# UNITED STATES PATENT AND TRADEMARK OFFICE

## Office Action Summary

10/711,580

## DETAILED ACTION

FIG. 5

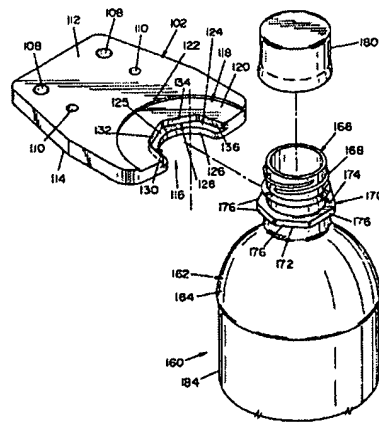
However, Peronek ('160) teaches wherein the mouth-forming portion comprises a polygonal-shaped flange perpendicular to the plane of the body-forming portion and where each isometric outside surface of the flange is substantially straight (*FIG-5, #170 and col. 16, l. 64 to col. 17, l. 8*) for the purpose of inhibiting or preventing rotation of the bottle during the capping process (*col. 18, ll. 25-37*).

Therefore, it would have been obvious to a person of ordinary skill in the art at the time applicant's invention was made to modify Sincock's ('120) bottle with the above polygonal-shaped flange as taught by Peronek ('160) in order to provide a bottle that inhibits or prevents rotation during capping.
